**Project #19-024
Logan River Trails – Phase 4
600 S Trail Circle**

Project Name: Logan River Trails – Phase 4
Proponent / Owner: Don Reese/Logan River Trails LLC
Project Address: 600 S Trail Circle
Request: 5 Lot Residential Subdivision
Current Zoning: Traditional Neighborhood Residential (NR-6)
Type of Action: Quasi-Judicial
Hearing Date: August 8, 2019
Submitted By: Aaron Smith, Planner II

Staff recommends that the Planning Commission **conditionally approve** a Subdivision Permit for Project #19-024, Logan River Trails – Phase 4, in the Traditional Neighborhood Residential (NR-6) zone located at 600 S Trail Circle, TIN# 02-077-0001

**FIGURE
1**

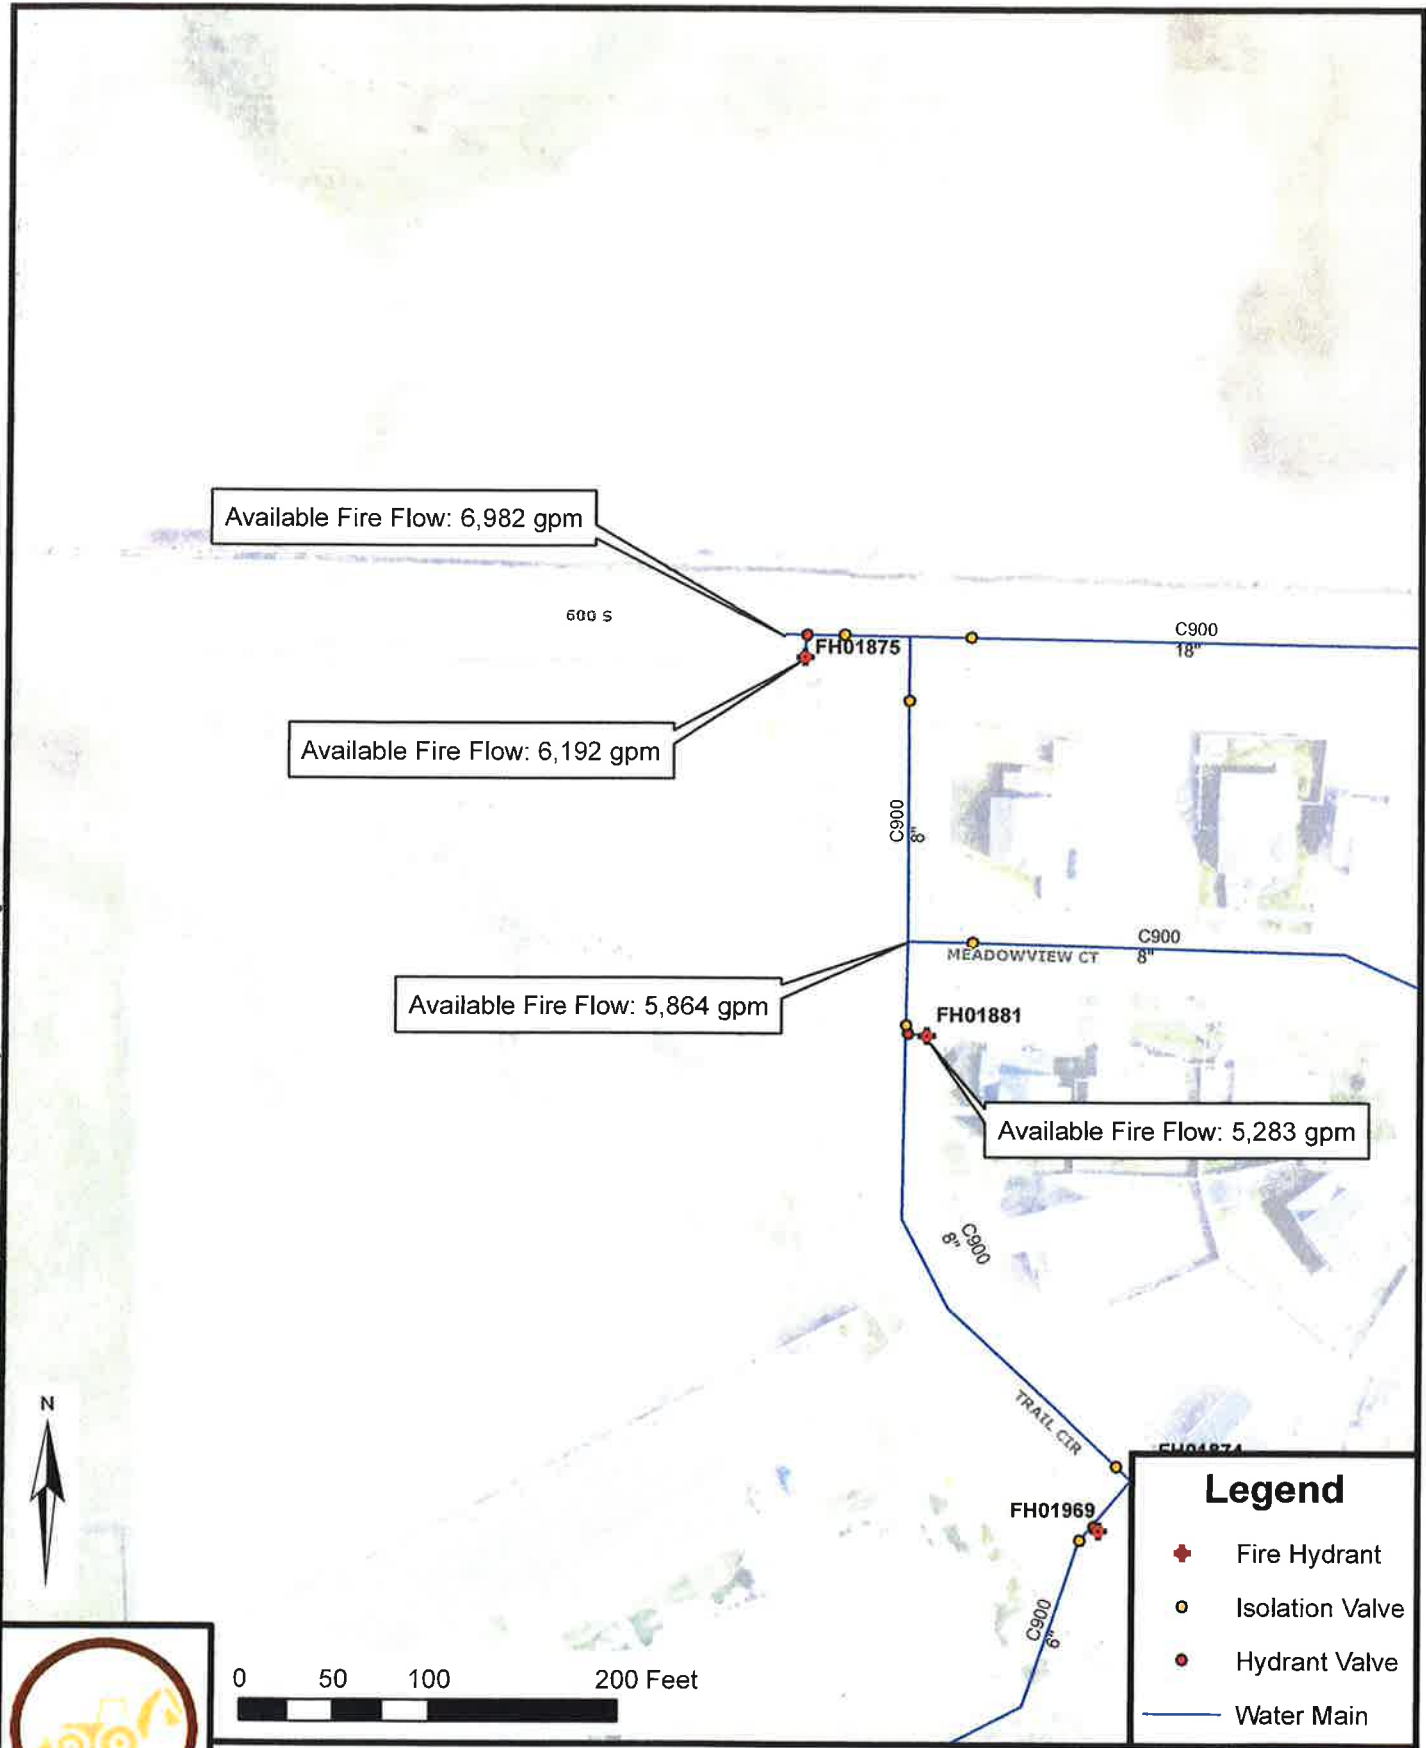
This information provides three points from which the developer's consultant can create a pressure versus flow curve to match the actual values. The actual design fire flow must be obtained from the Fire Marshall prior to completing the hydraulic analysis. Figure 1 shows the locations of this fire flow analysis.

**LOGAN RIVER TRAILS SUBDIVISION
PHASE 4**

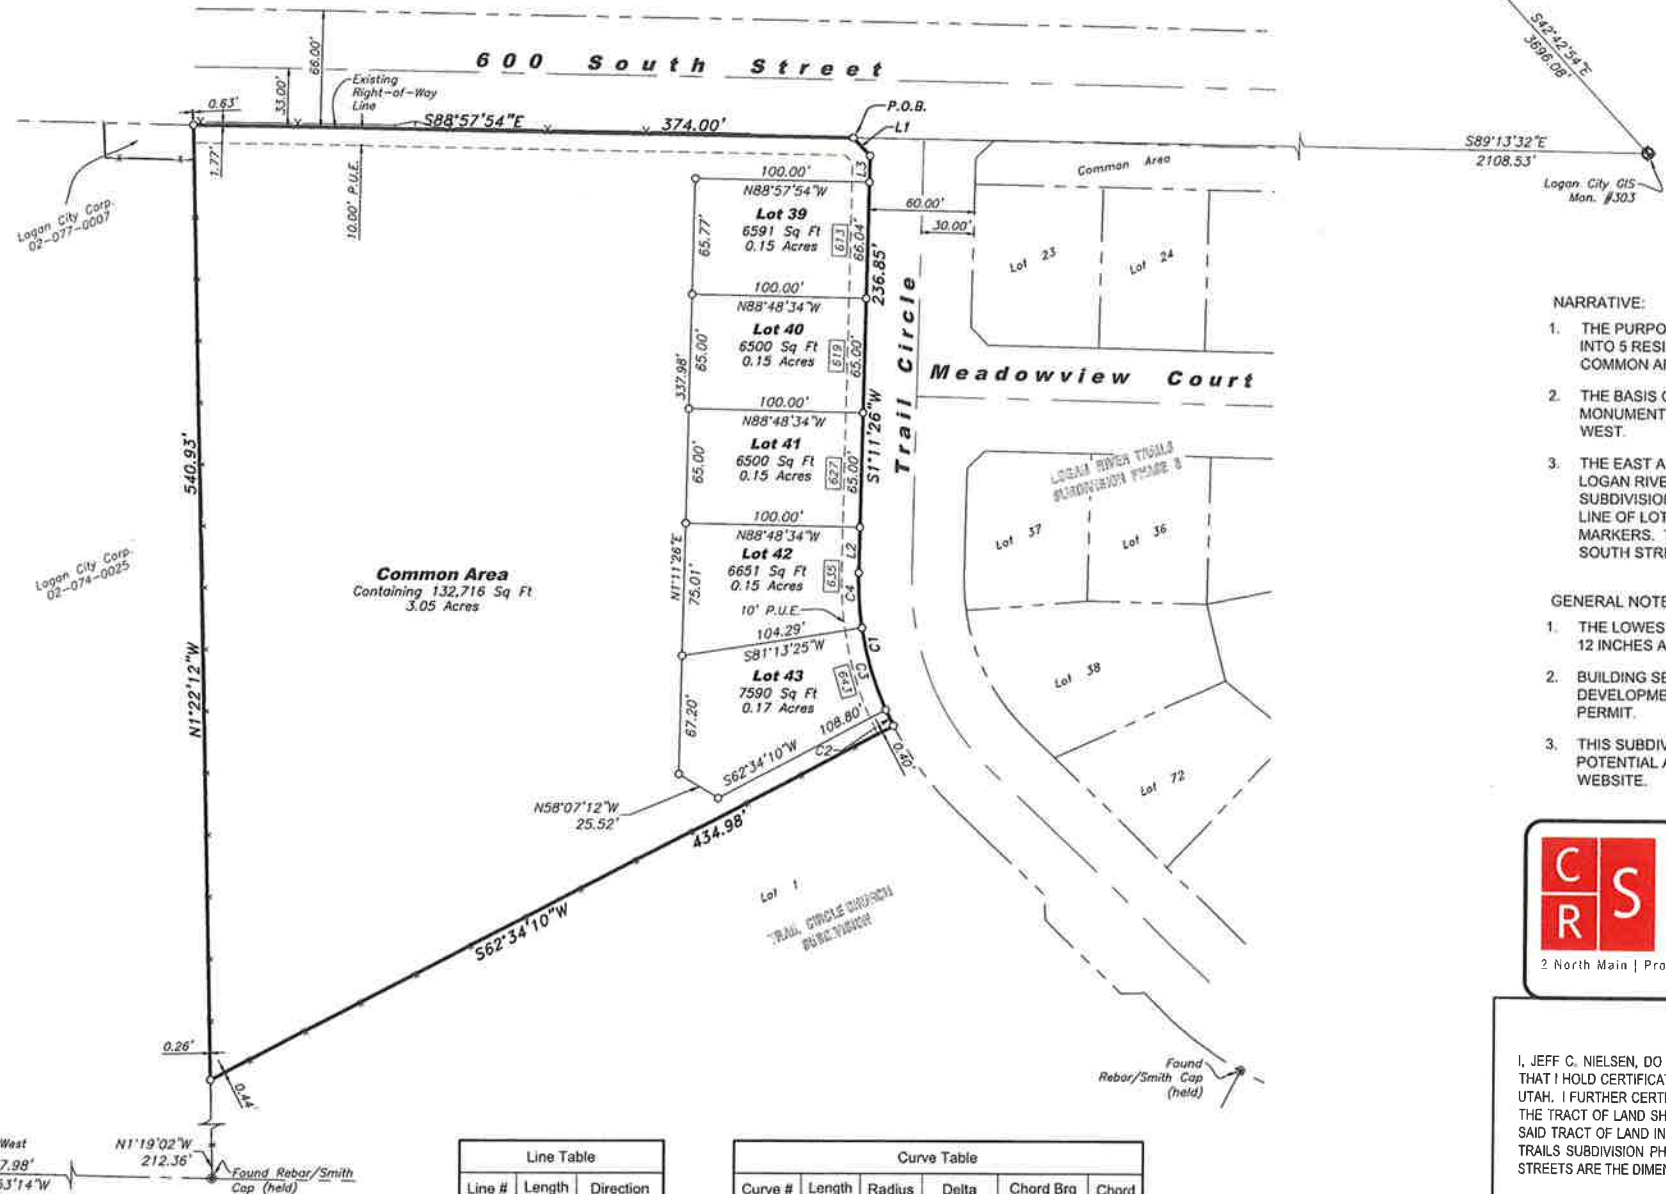
3. Full streetscape improvements, including curb, gutter, park-strip and sidewalk, shall be made to both Trail Circle and 600 South.
4. A 25' landscaping buffer that matches the existing buffer along 600 S adjacent to previous phases shall be installed in the common area along the northern edge of Lot 39.

8. The common area shall be designated as not buildable on the Final Plat.
9. The final plat shall be recorded within one (1) year of this action, or comply with LDC 17.58 Expirations and Extensions of Time.

- a. Light and Power:
 - i. PUE's- Public Utility Easements on all property lines (10' PUE on all property lines facing a road and a 5' PUE on all other property lines)

- b. Engineering:
 - i. Construct road, curb gutter and sidewalk and drainage along 600 South and Logan River Circle.
 - ii. Provide Storm water detention/retention per current Logan City Design Standards.

- iii. Extend water line in 600 South to west subdivision limits and install fire hydrant at end of line with an in-line gate valve.
 - iv. Ensure CC&R's are in place to address maintenance of common area and infrastructure.
